Proposed Residential Development, Kingsway, Burnage

Highways Technical Note

Response to Highways Comments from Manchester City Council and Transport for Greater Manchester

31st January 2025

Drawn By: ECT	Date: 31.01.2025	
Checked: SD	Scale: 1:200	Paper: A3
Drawing No. AMA-21894-ATR-005.1	Rev. P02

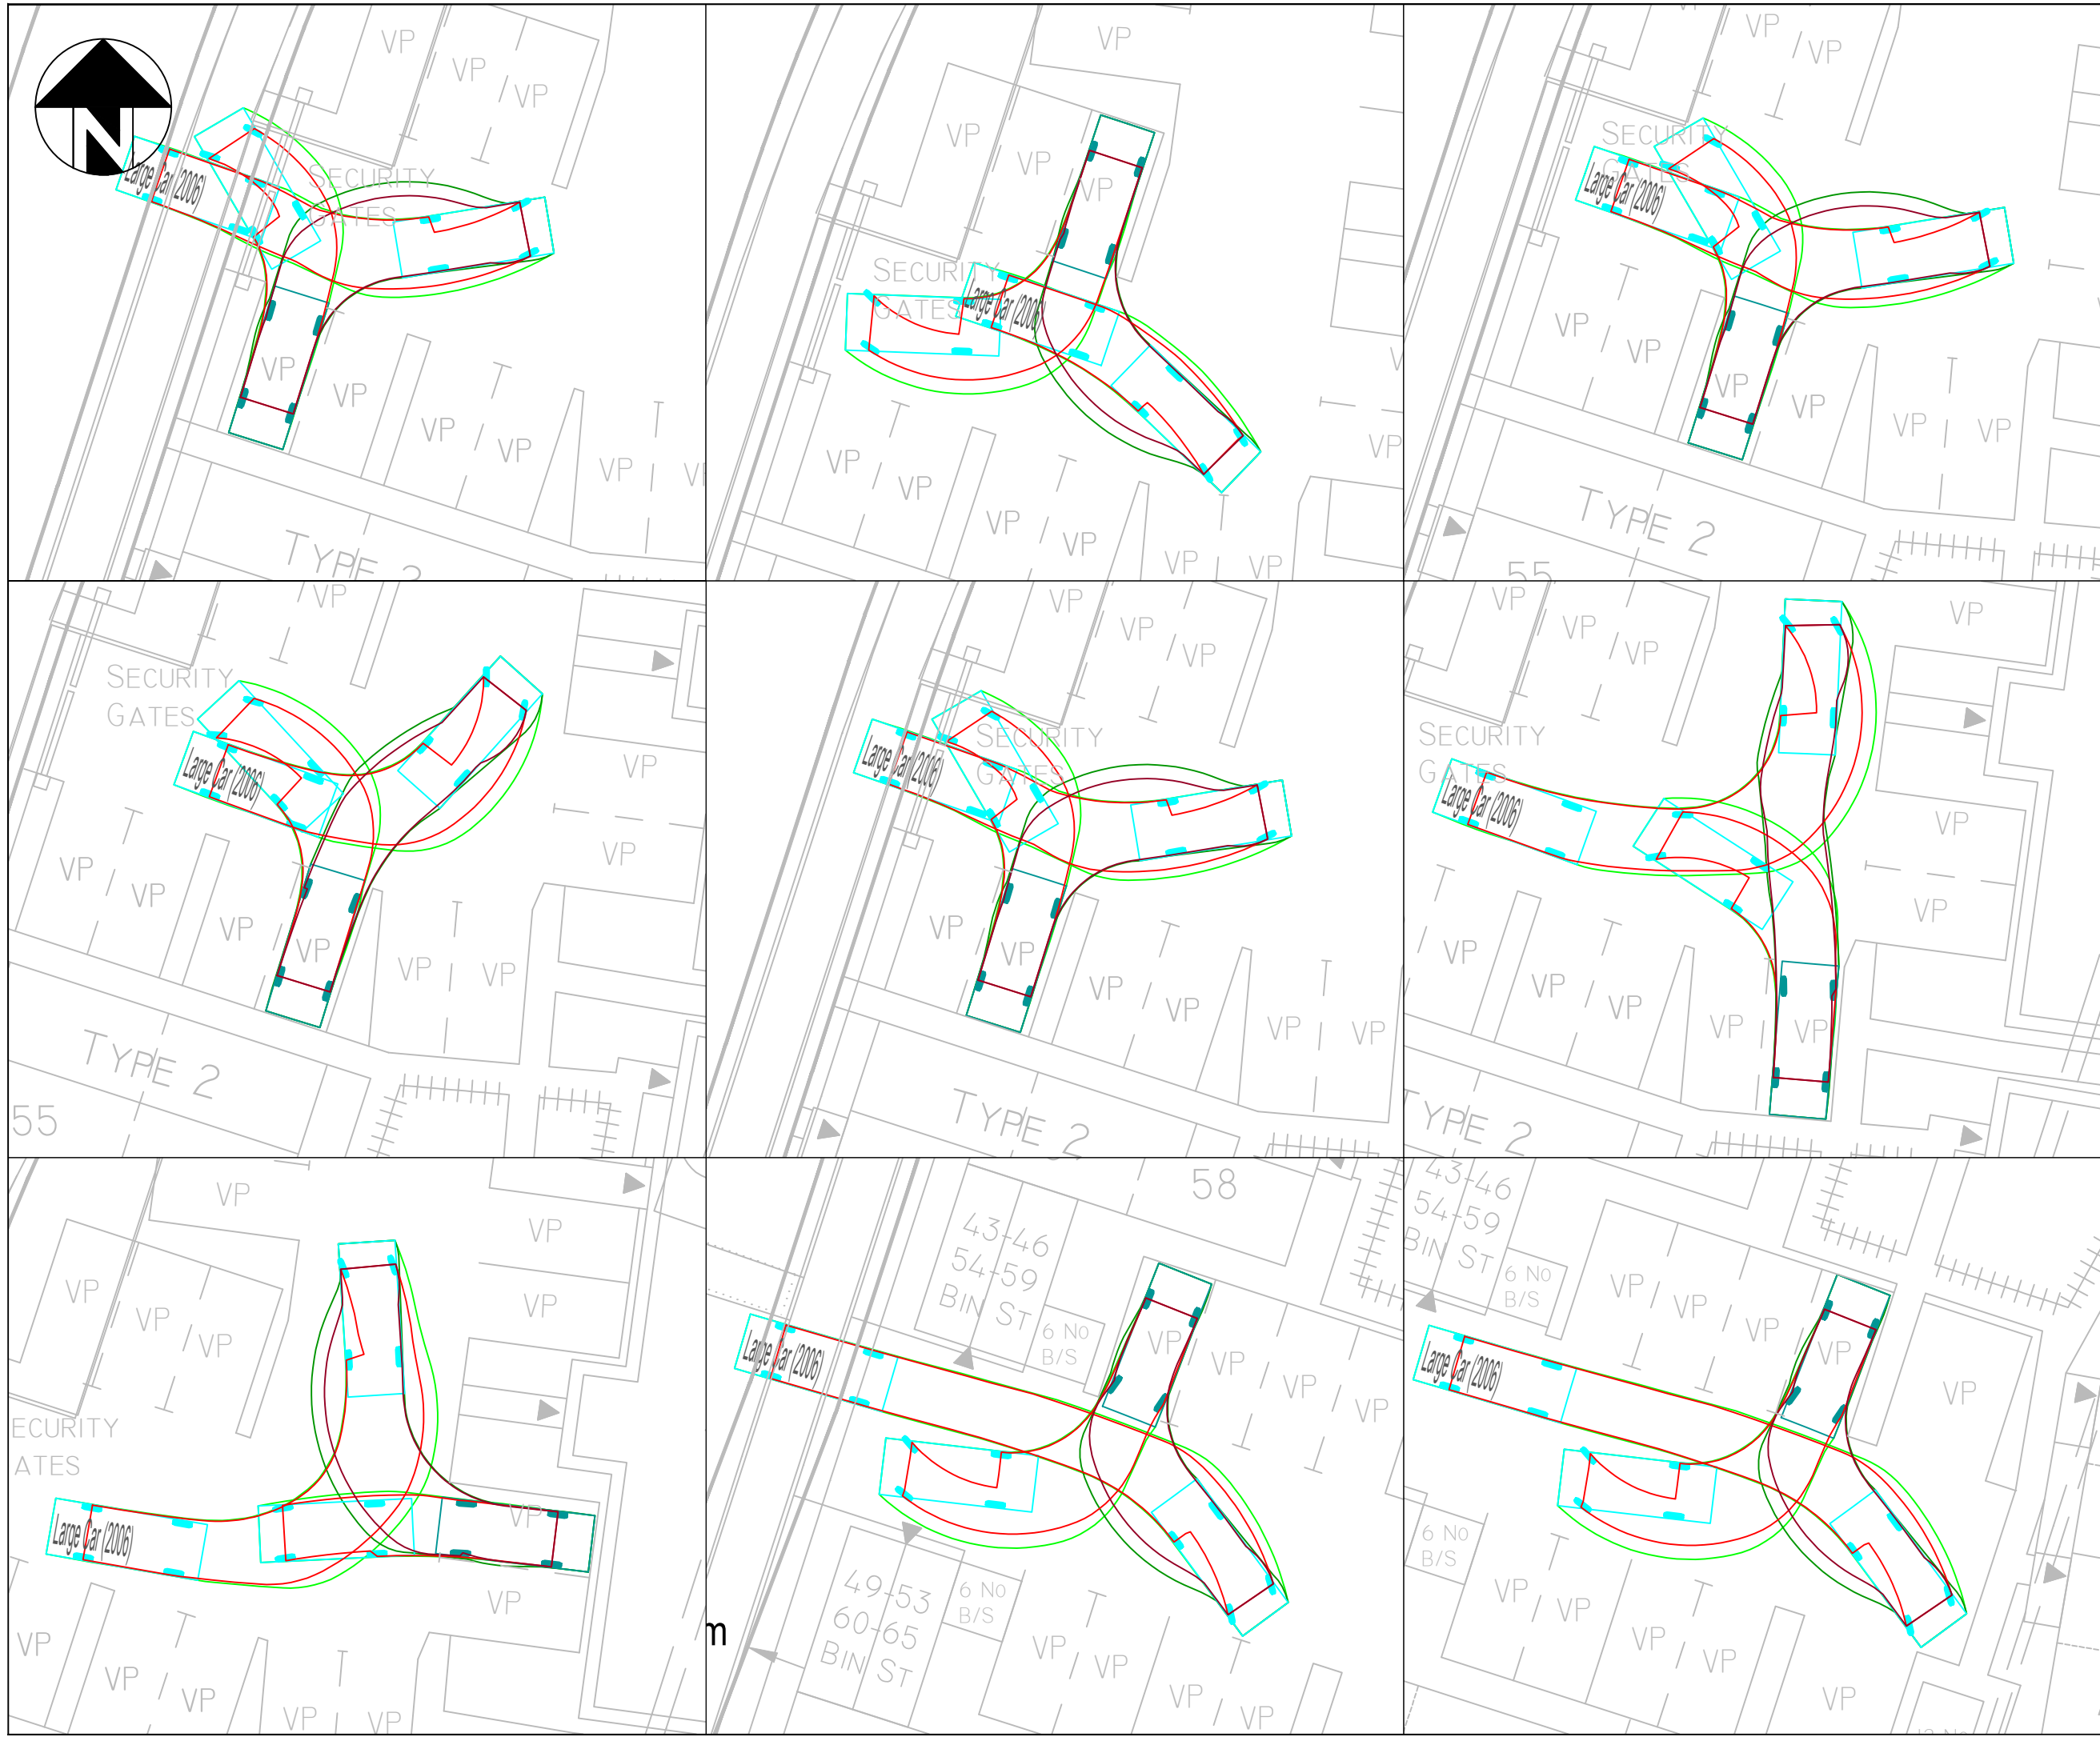
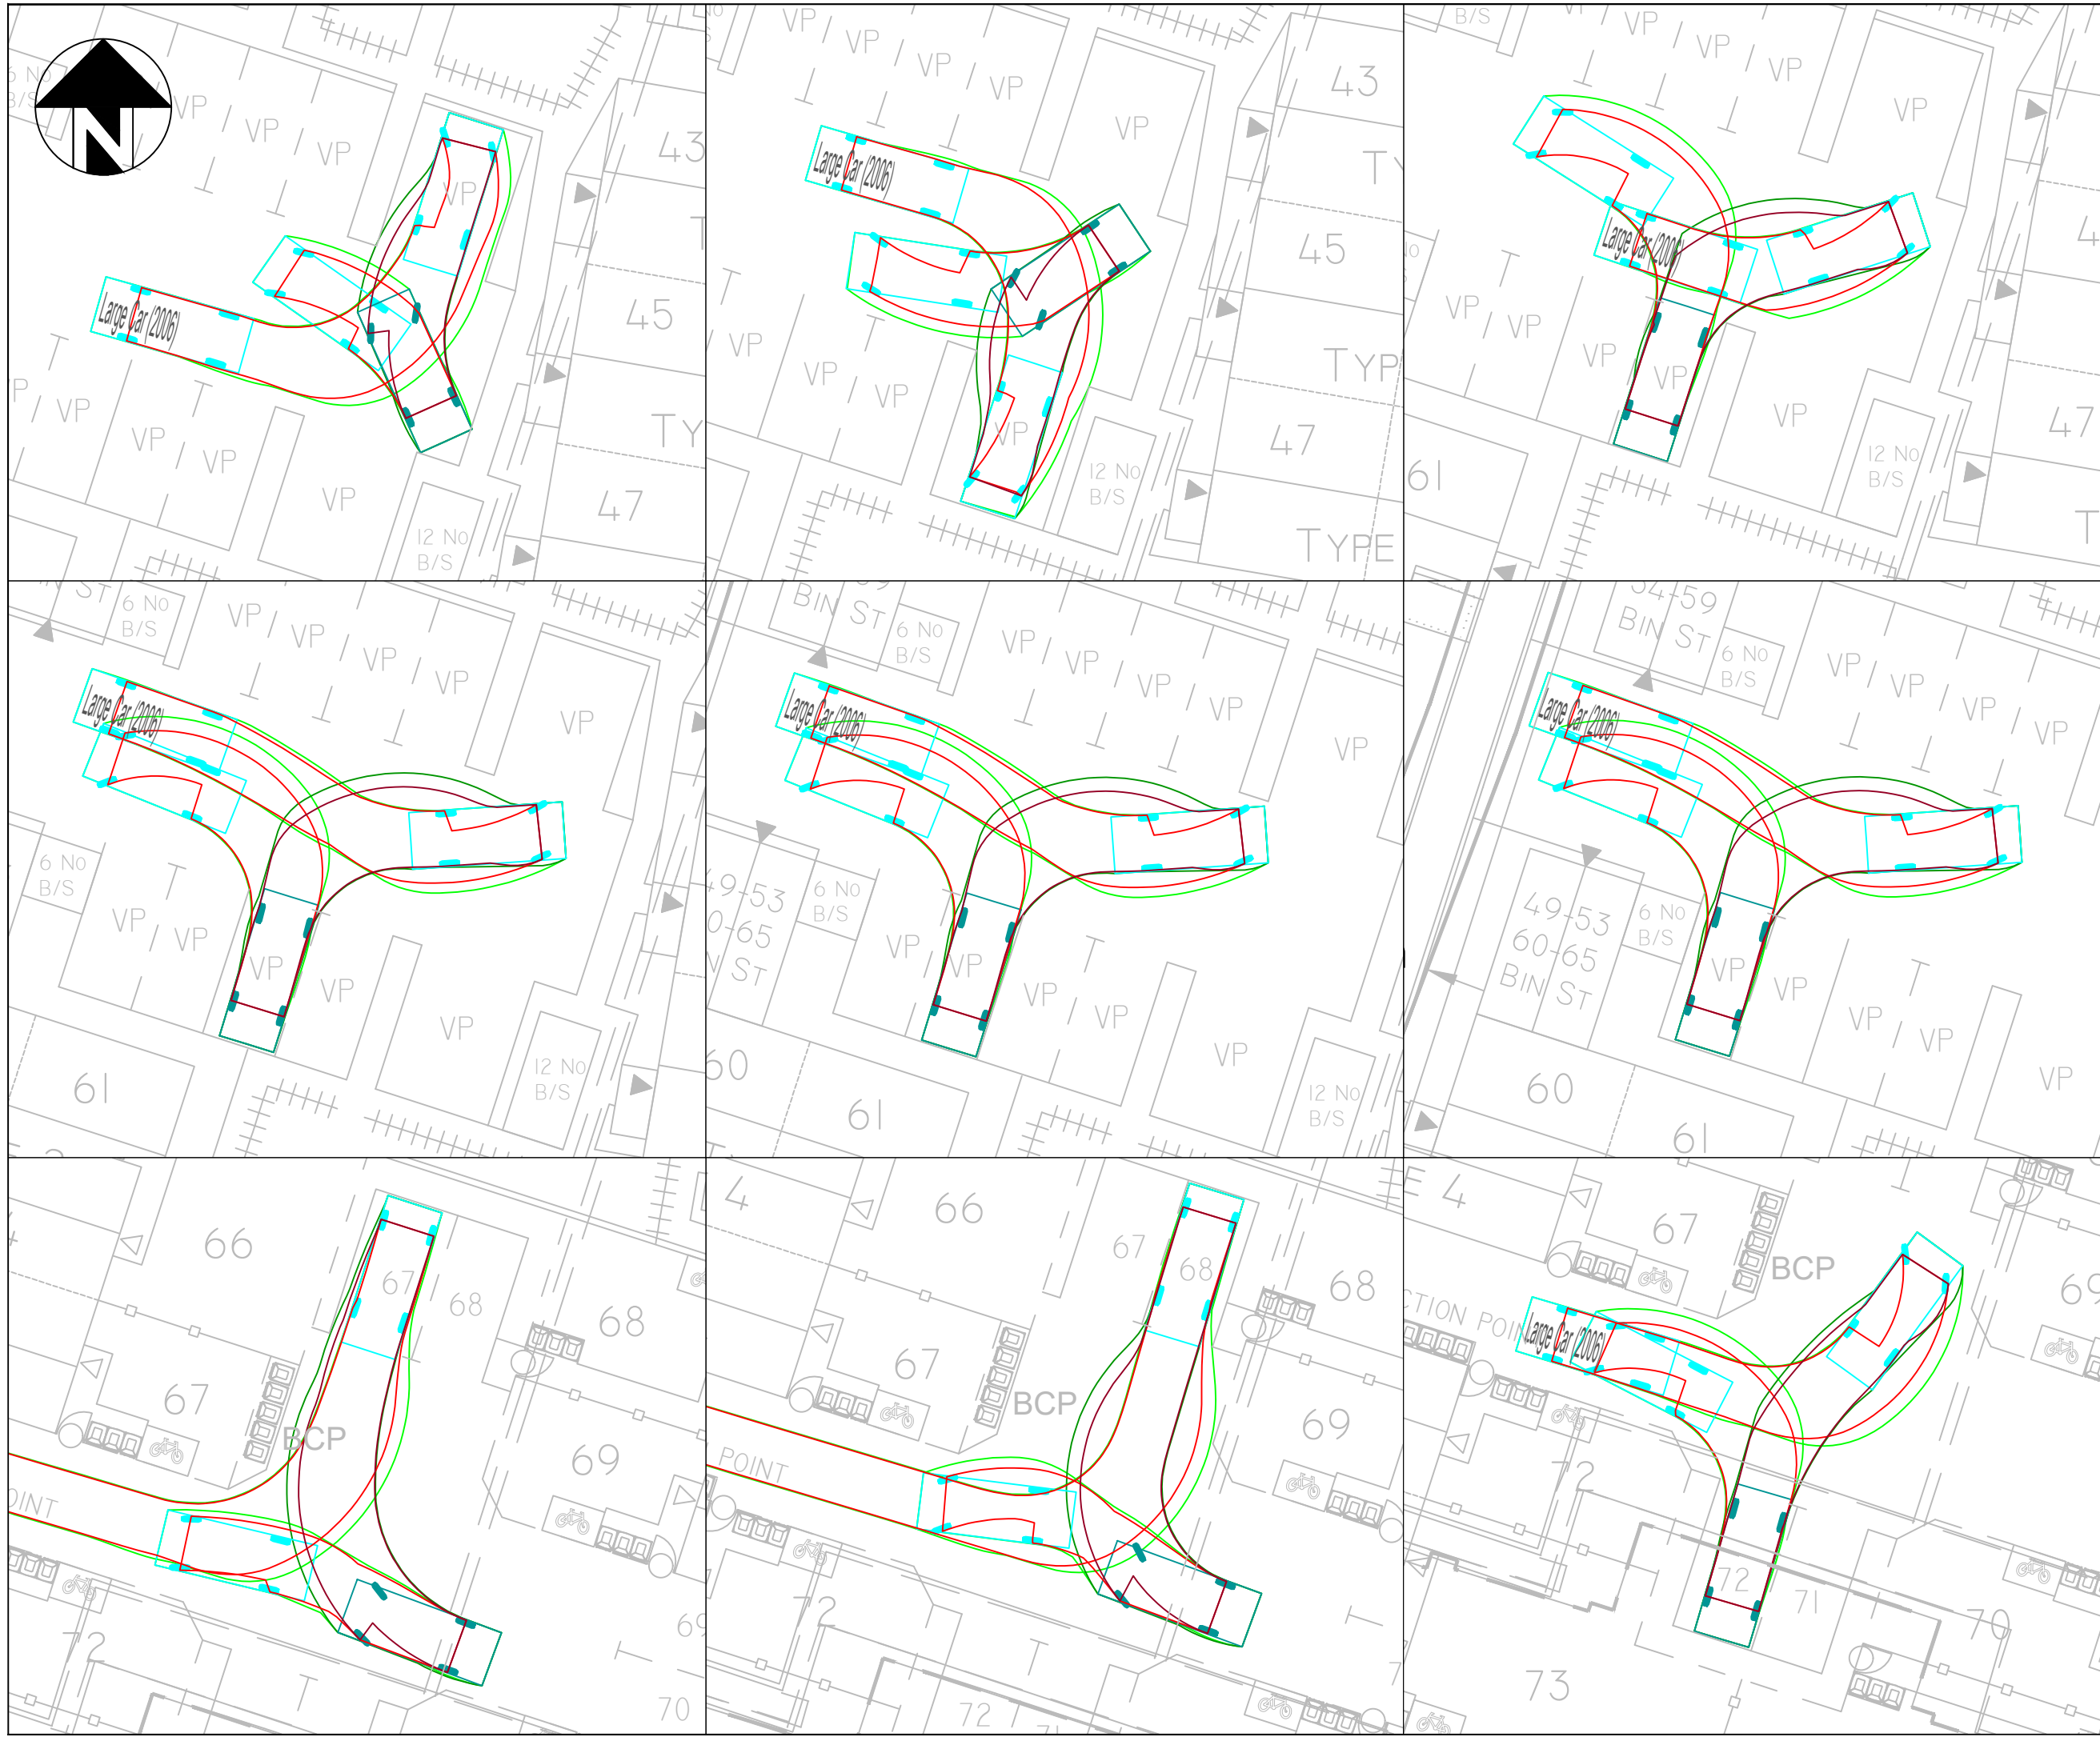
The plan shows allocated courtyard parking with new access points from the access road. It should be ensured that dropped kerbs and tactile paving is provided at each access point and sufficient visibility splays should be in place. It is requested that swept path of vehicles manoeuvring to/from the proposed car park spaces is provided.

As requested, swept path analysis of car parking spaces is provided at [Appendix D](#).
